**OHIO TURNPIKE AND
INFRASTRUCTURE COMMISSION**

ADDENDUM NO. 1

SERVICE PLAZA RENOVATIONS

**CHANGES TO PLAN DRAWINGS
Sheet Number 6-A4.0, 6-A7.6, 6-8.1, 7-AS1.0 and 7-A8.1**

SHEET NUMBER:
6-A4.0

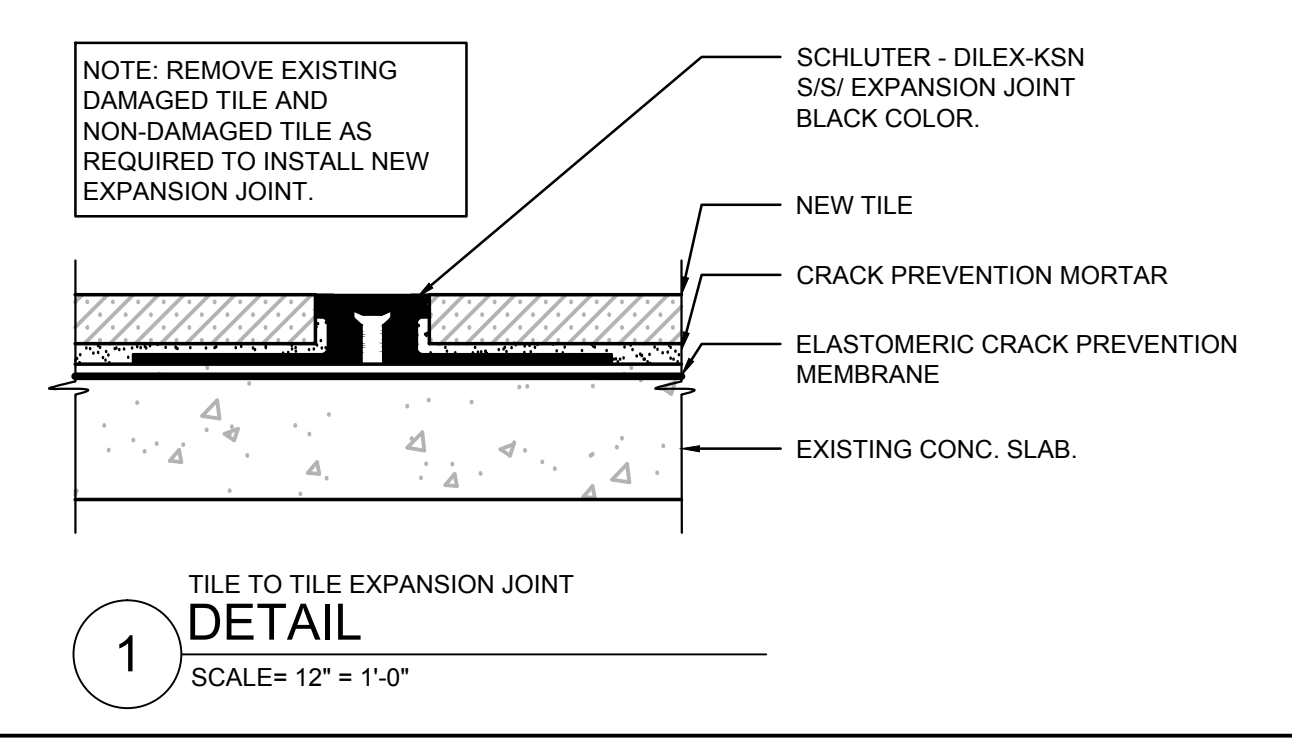
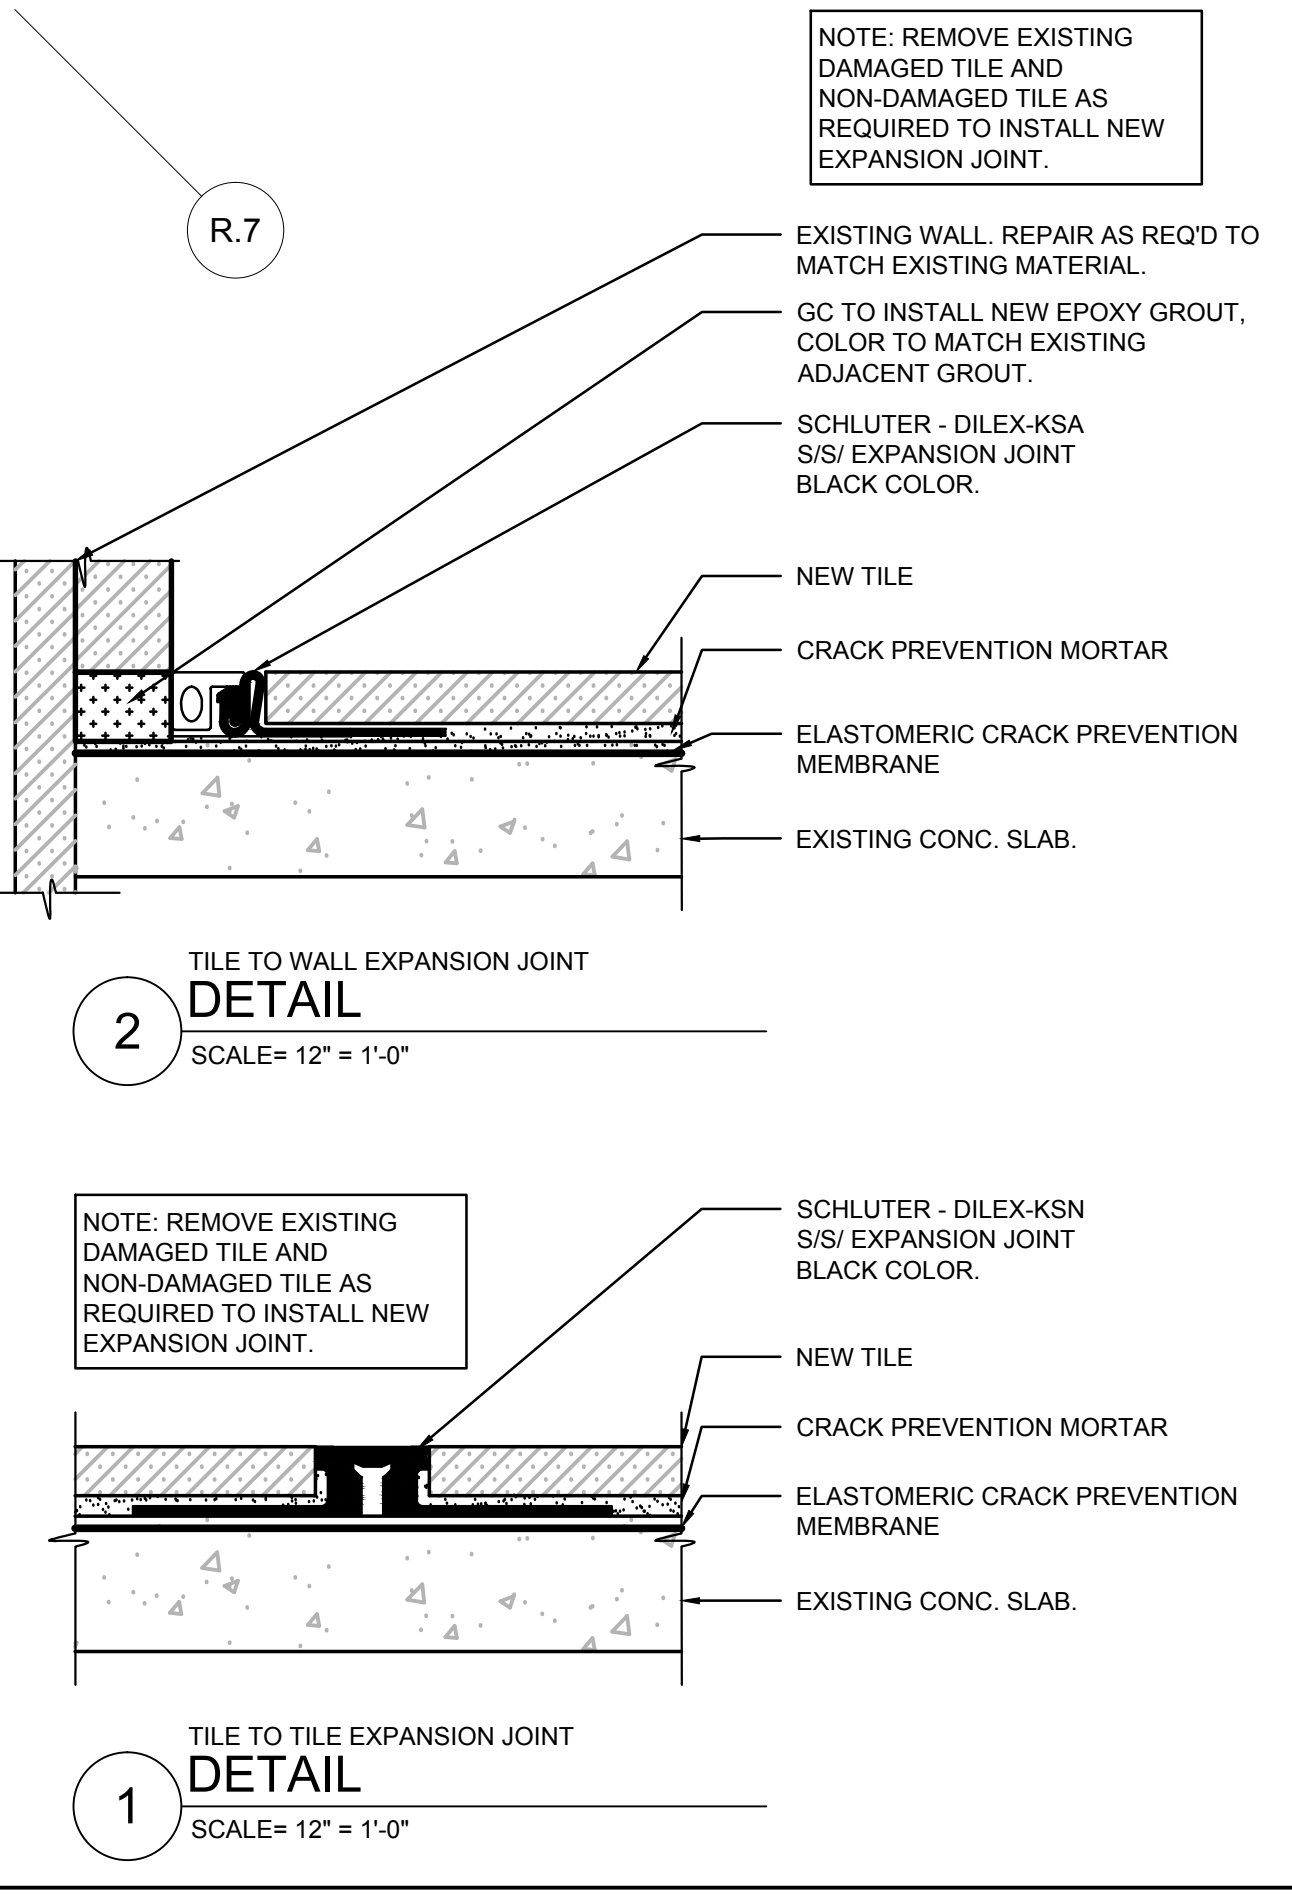
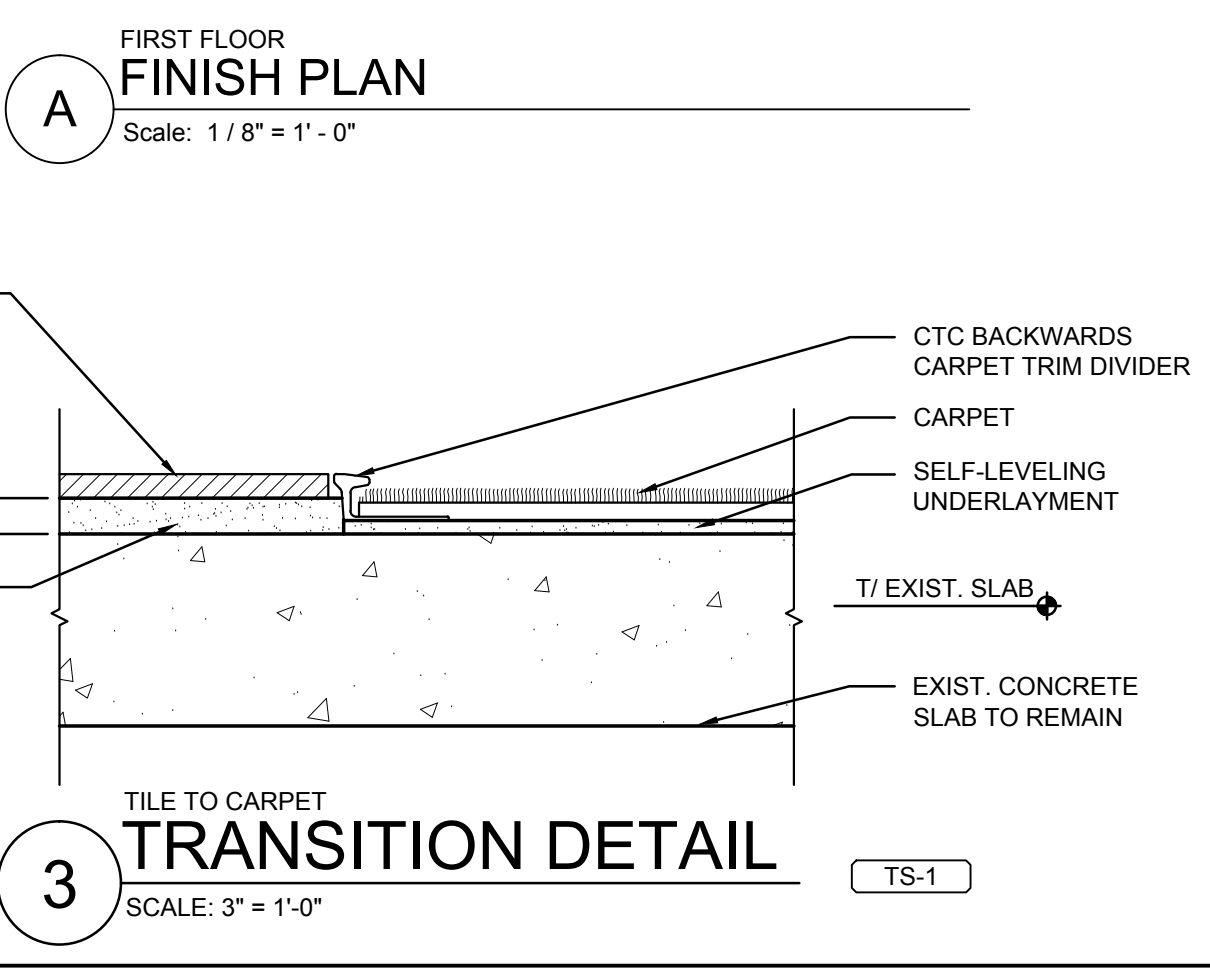
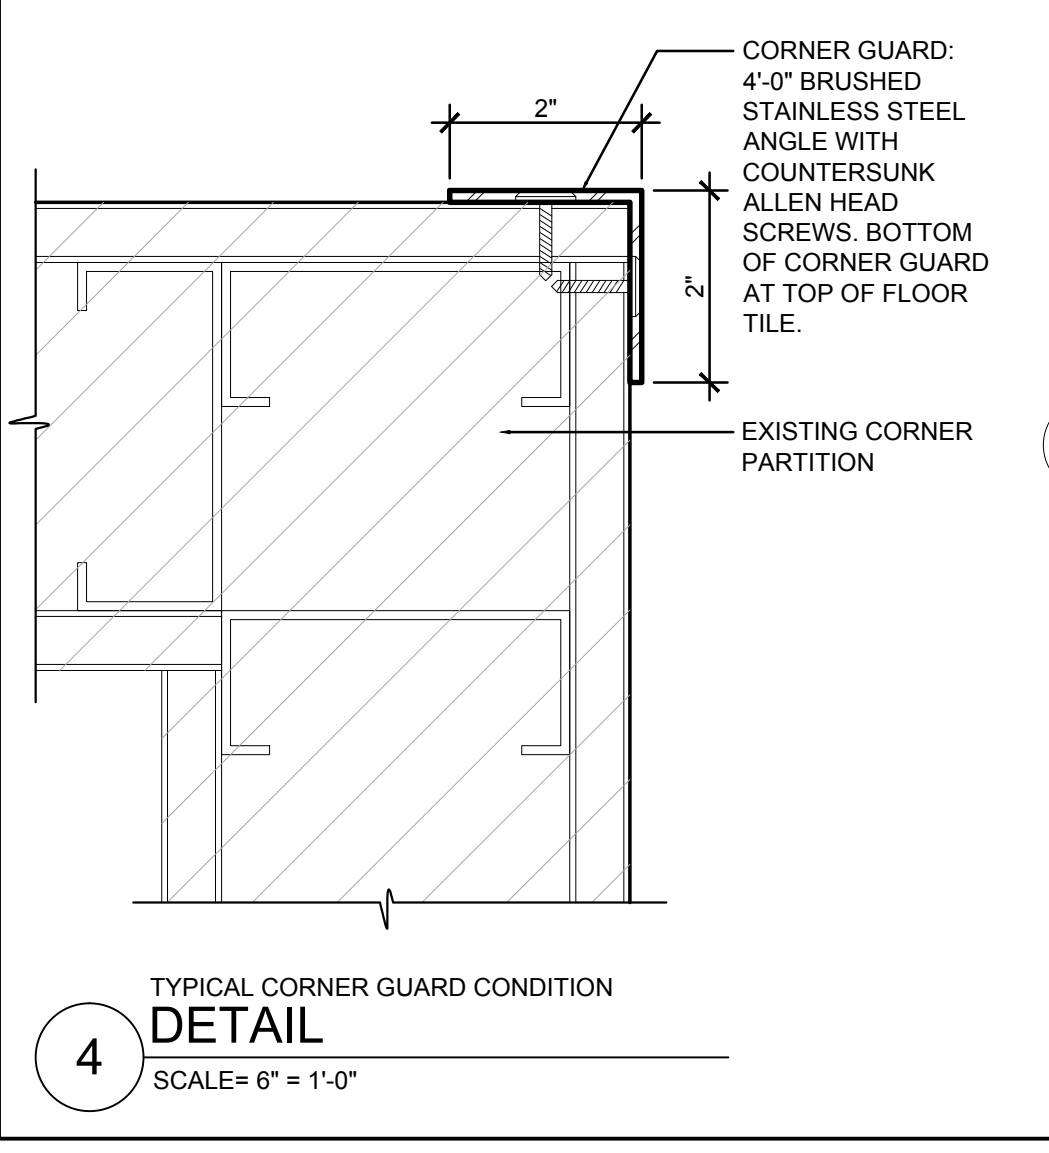
Q#10 On drawing 6-A4.0, in Vendor Lobby 229, it shows FRP-1 but it also calls out DP-1 which is 1/8" aluminum diamond plate base HT=4'-0". Please clarify if the diamond plate should cover the first 4 feet of the wall with FRP above. Wall section 7 on 6-A7.3 shows FRP 4'-0" from finish floor with rubber base?

A#10 DP-1 wall treatment is NOT to be used on the Vendor Lobby walls. FRP-1 wall treatment is to be used on the Vendor Lobby walls with rubber base. This affects 6-A4.0 Plan Sheet.
